**Princeton Engineering Department
Municipal Evaluation of the Various Valley Road Design Options Presented by Sam Bunting
at the 6/15/15 Neighborhood Meeting
September 2015**

Options to consider for a safer
Valley Road

'Option 1'

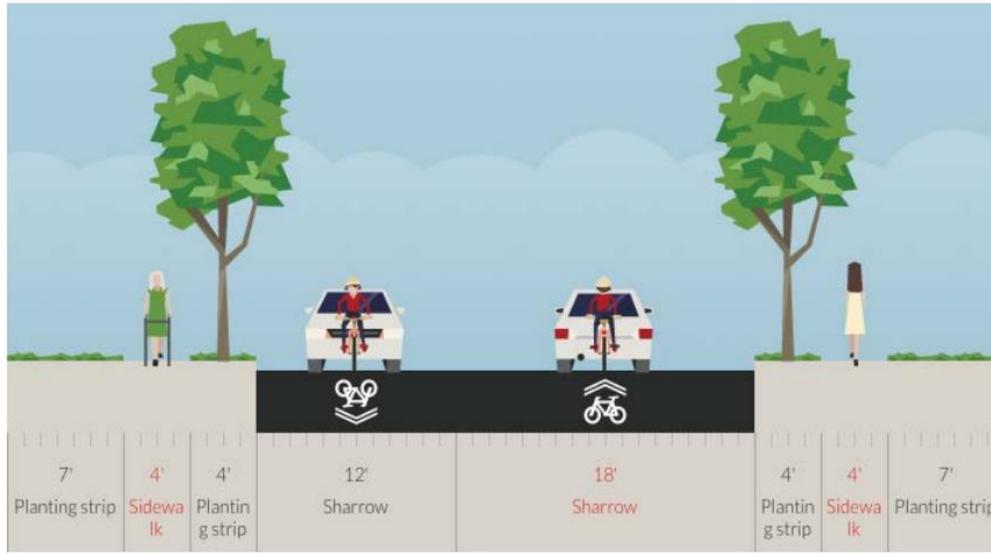
Municipal Evaluation of Option 1:

- The proposed pavement width of 30' fits generally within the existing paved area of Valley Road. Some areas may need to be narrowed by one foot to accommodate existing trees.
- The slide to the left is not clear whether the 18' sharrow provides for 7' parking lane and 11' travel lane. For this analysis, we will propose that parking is retained and included.

Although the 11' lane (18' total lane width less 7' parking) currently exists, it does not meet the currently adopted roadway design standard of a 12' wide lane for a minor collector as shown at:

- Sharrows provide extra recognition on the roadway for bicyclists.
- Per AASHTO Bicycle Design Guidelines, there is no minimum lane width for use of sharrows. Sharrows on roadways with a speed of 35 mph or faster and a volume higher than 3,000 vehicles per day is not a preferred treatment per NACTO. As only one of these parameters is exceeded, sharrows can be an acceptable option on this roadway.

- Existing intersection layouts at Harrison and Witherspoon can accommodate sharrows without modification. We note that Harrison Street at this location is currently marked with sharrows.

- If desired, the above layout can accommodate curb extensions / bumpouts to reduce pedestrian crossing distances.
- Placement of leaf and brush piles for pick up could continue where permitted in the roadway, as currently takes place.

- The above slide does not show a double yellow centerline roadway stripe. Valley Road currently has this type of centerline striping, and it will be retained in the final design.

Municipal Evaluation of Option 2:

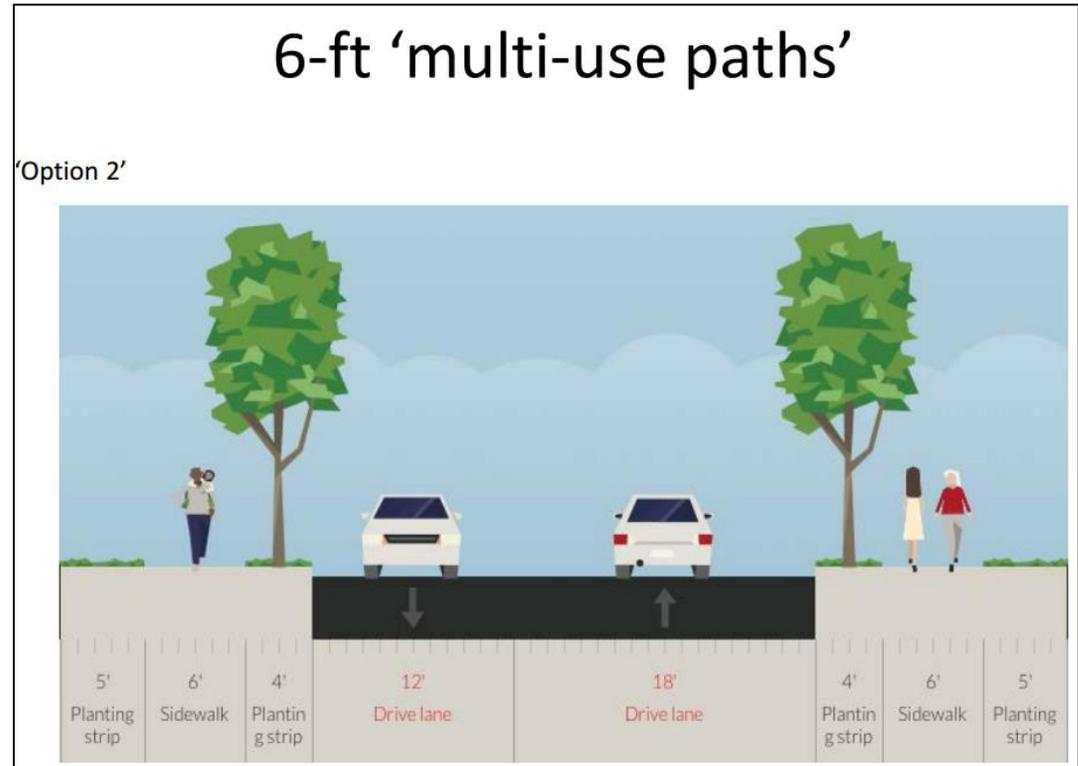
- The proposed pavement width of 30' fits generally within the existing paved area of Valley Road. Some areas may need to be narrowed by one foot to accommodate existing trees.
- The slide to the right is not clear whether the 18' lane provides for 7' parking lane and 11' travel lane. For this analysis, we will propose that parking is retained and included.

Although the 11' lane (18' total lane width less 7' parking) currently exists, it does not meet the currently adopted roadway design standard of a 12' wide lane for a minor collector as shown at:

- 6' sidewalks are non-compliant with current standards for multi-use pathways. However, it does provide 2 extra feet for accommodating users.
- No recognition is provided on the roadway for bicyclists.
- If desired, this layout can accommodate curb extensions / bumpouts to reduce pedestrian crossing distances.
- Placement of leaf and brush piles for pick up could continue where permitted in the roadway, as currently takes place.
- The above slide does not show a double yellow centerline roadway stripe. Valley Road currently has this type of centerline striping, and it will be retained in the final design.

'Option 3'

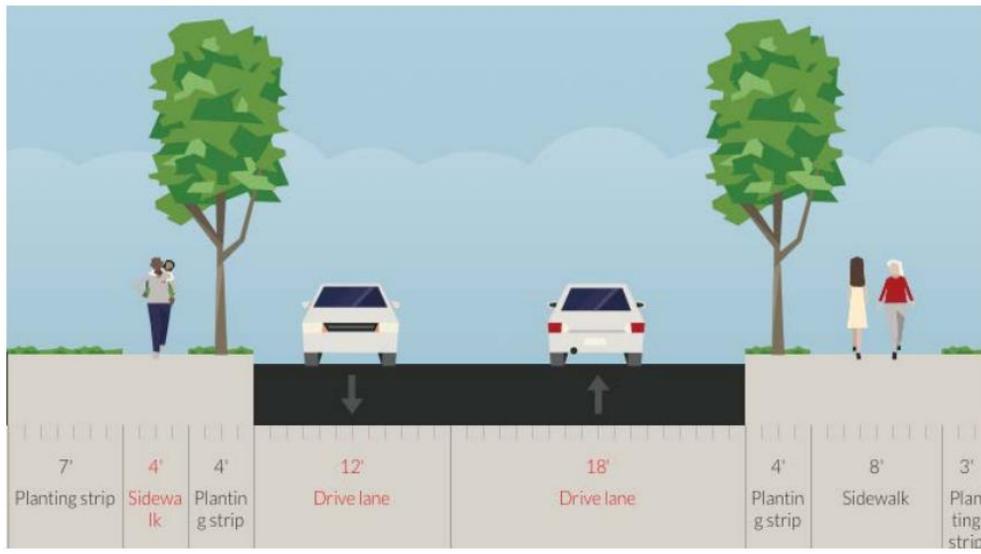
Municipal Evaluation of Option 3:

- The proposed pavement width of 30' fits generally within the existing paved area of Valley Road. Some areas may need to be narrowed by one foot to accommodate existing trees.
- The slide to the left is not clear whether the 18' lane provides for 7' parking lane and 11' travel lane. For this analysis, we will propose that parking is retained and included.

Although the 11' lane (18' total lane width less 7' parking) currently exists, it does not meet the currently adopted roadway design standard of a 12' wide lane for a minor collector as shown at:

- 4' sidewalk is compliant with current standards for sidewalks.
- 8' sidewalk is the narrowest compliant width of a multi-use path.
- 20+ driveways on the side of the road and intersecting roadways provide potential conflict points for a multi-use side pathway.
- No recognition is provided on the roadway for bicyclists.
- Due to the existing 50' right of way width between Ewing and Harrison, the installation of an 8' wide multi-use path would require the narrowing of the westbound travel lane and moving of the existing curbs to keep the improvements within municipal property.
- The above slide does not show a double yellow centerline roadway stripe. Valley Road currently has this type of centerline striping, and it will be retained in the final design.

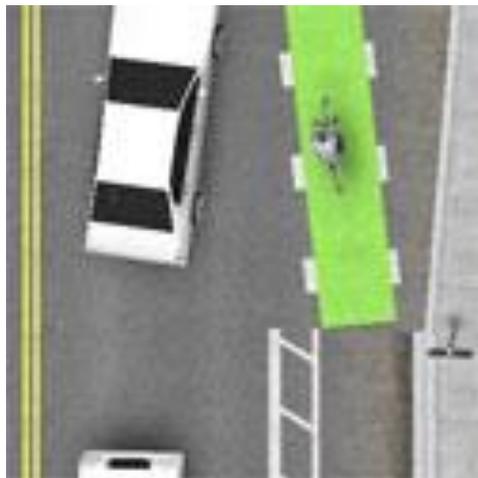
- Special treatment, similar to that shown below, is needed to carry the bike lane past the dedicated right turn only lane from EB Valley to SB Harrison.

'Option 5'

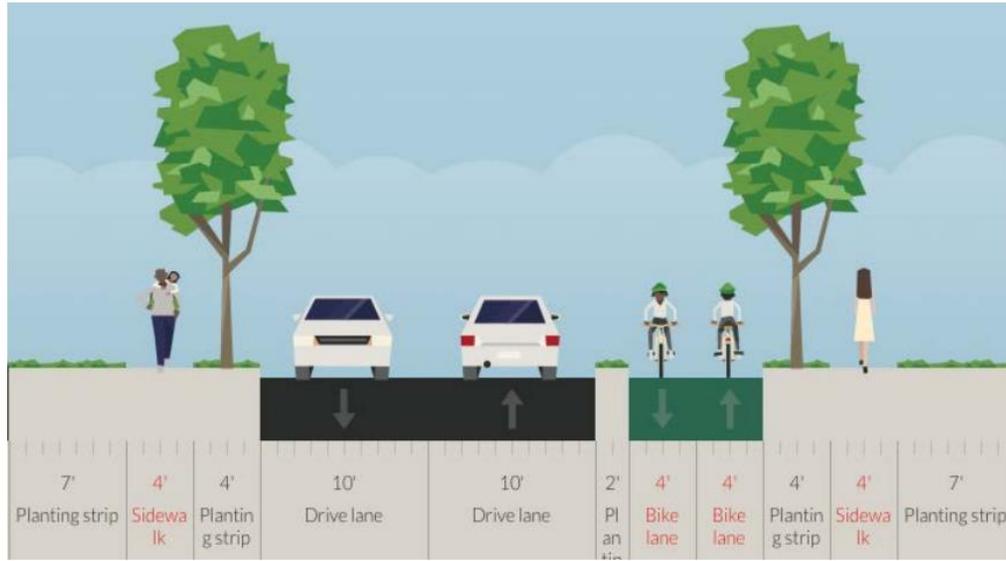
Municipal Evaluation of Option 5:

- The proposed width of 30' fits generally within the existing paved area of Valley Road. Some areas may need to be narrowed by one foot to accommodate existing trees.

- Per the currently adopted roadway design standards, 12' wide lanes shall be provided for a minor collector as shown at: <http://www.princetonnj.gov/masterplan/appendix-B-classification%20roadwaydesign.pdf>.

- The slide does not show a double yellow centerline roadway stripe. Valley Road currently has this type of centerline striping, and it will be retained in the final design.
- On-street parking is prohibited in this option. Removal of parking between Witherspoon Street and Harrison Street is not

- If service vehicles (FedEx, UPS, USPS, landscapers, garbage trucks, etc.) stop in the roadway briefly, only one lane of traffic may be able to pass.
- The image shows green bike lanes. There are two ways to create green bike lanes: paint or colored asphalt. Both treatments are more costly for construction and maintenance. It will be more costly for the Public Works Department to repair and questionable if the municipality can require the utility companies to repair colored pavement patches in colored bike lane areas in the future, if the municipality institutes a colored bike lane policy.

It is our opinion that the street typology described above does not match Valley Road.

- The 8' width is less than the NACTO-desired 12' minimum width for a protected two way cycle track.
- The 2' raised buffer exceeds minimum FHWA 16" wide standards.

- A 2' wide planting strip would be able to accommodate 1' width of vegetation, as curbing would take the other 1'. Public Works does not have the staff to maintain a 1' wide planted buffer between drive and bike lanes. Additionally, the chosen vegetation material would have to be immune to road salt as this is an exposed area subject to snow piles. The vegetation will not be permitted to be taller than 24" tall and cannot extend past the curbs.

- 20+ driveways and intersecting roadways provide cross traffic from the road edges. A raised bike lane buffer will have to accommodate openings at each driveway and intersecting roadway. The two direction bike lanes will provide more visual conflict for drivers exiting the driveways and intersecting roadways to process. NACTO has preferred treatments for these locations in the image above.

- If bike lanes are to carry through to the Valley / Harrison and Valley / Witherspoon intersections, widening will be required.
- This option requires the purchase of additional right of way and relocation of utility poles between Ewing Street and Harrison Street if the bike lanes are to continue through this section of the roadway. The existing right of way is 50 feet wide and contains 38 feet of roadway and 8 feet of sidewalks currently.

- This option does not provide much flexibility in modifying the intersections at Jefferson, Walnut and Ewing to calm traffic and increase intersection sight distance.

Municipal Evaluation of Option 5*:

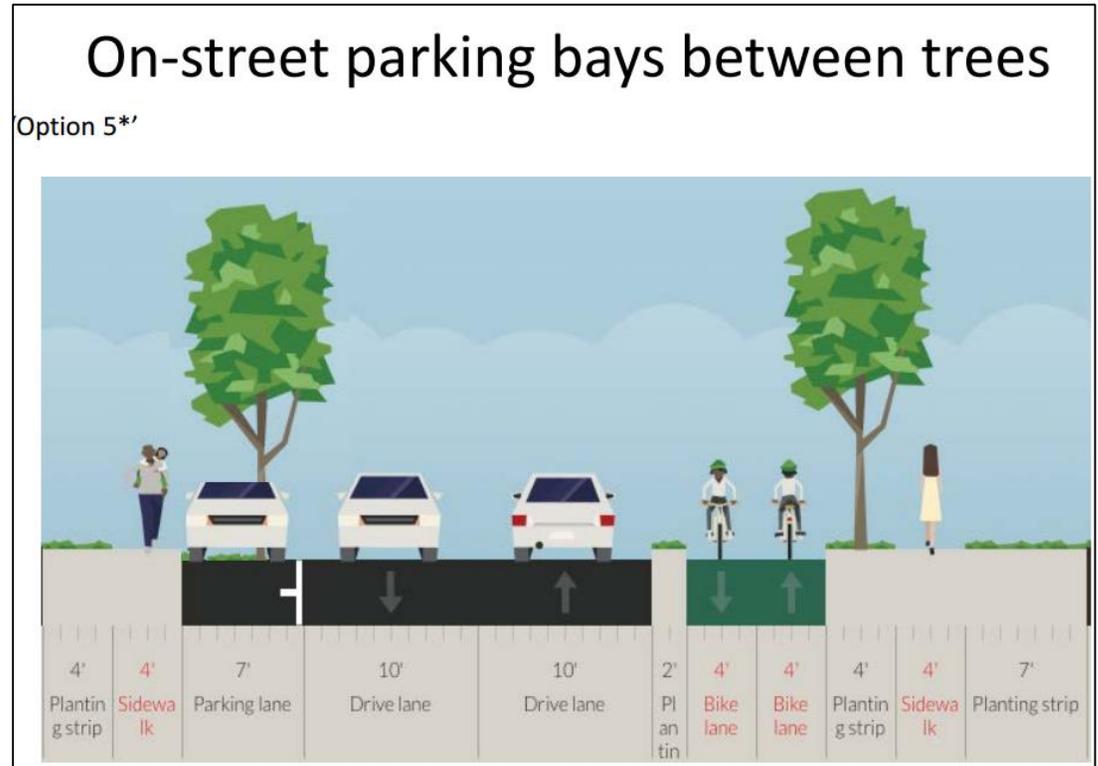
- The proposed main pavement width of 30', exclusive of the parking lane, fits generally within the existing paved area of Valley Road. Some areas may need to be narrowed by one foot to accommodate existing trees.
- The slide does not show a double yellow centerline roadway stripe. Valley Road currently has this type of centerline striping, and it will be retained in the final design.
- Per the currently adopted roadway design standards, 12' wide lanes shall be provided for a minor collector as shown at:

- The 7' wide parking lane will push the sidewalk back into what is perceived as "front lawns", although it is within the municipal right of way.
- The image shows green bike lanes. There are two ways to create green bike lanes: paint or colored asphalt. Both treatments are more costly for construction and maintenance. It will be more costly for the Public Works Department to repair and questionable if the municipality can require the utility companies to repair colored pavement patches in colored bike lane areas in the future, if the municipality institutes a colored bike lane policy.

- A 2' wide planting strip would be able to accommodate 1' width of vegetation, as curbing would take the other 1'. Public Works does not have the staff to maintain a 1' wide planted buffer between drive and bike lanes. Additionally, the chosen vegetation material would have to be immune to road salt as this is an exposed area subject to snow piles.

- 20+ driveways and intersecting roadways provide cross traffic from the road edges. A raised bike lane buffer will have to accommodate openings at each driveway and intersecting roadway.

- Existing tree spacing ranges from 30' to 45'. Parking spaces must be at least 35' to accommodate tree trunks and the parking. In general, two parking spaces per block can be accommodated within the tree spacing; however, this does not take into consideration the tree root system. Existing tree roots can sustain damage due to the installation of the parking bays, which may lead to the decline and death of the tree.

It is our opinion that the street typology described above does not match Valley Road.

- The 8' width is below the NACTO desired 12' minimum width for a protected two way cycle track.
- If bike lanes are to carry through to the Valley / Harrison and Valley / Witherspoon intersections, widening will be required.

- This option requires the purchase of additional right of way and relocation of utility poles between Ewing Street and Harrison Street if the bike lanes are to continue through this section of the roadway. The existing right of way is 50 feet wide and contains 38 feet of roadway and 8 feet of sidewalks currently.

- This option does not provide much flexibility in modifying the intersections at Jefferson, Walnut and Ewing to calm traffic and increase intersection sight distance. In fact, parked cars between the existing trees may further reduce sight distance at the intersections of these roadways; this may result in the loss of on-street parking.
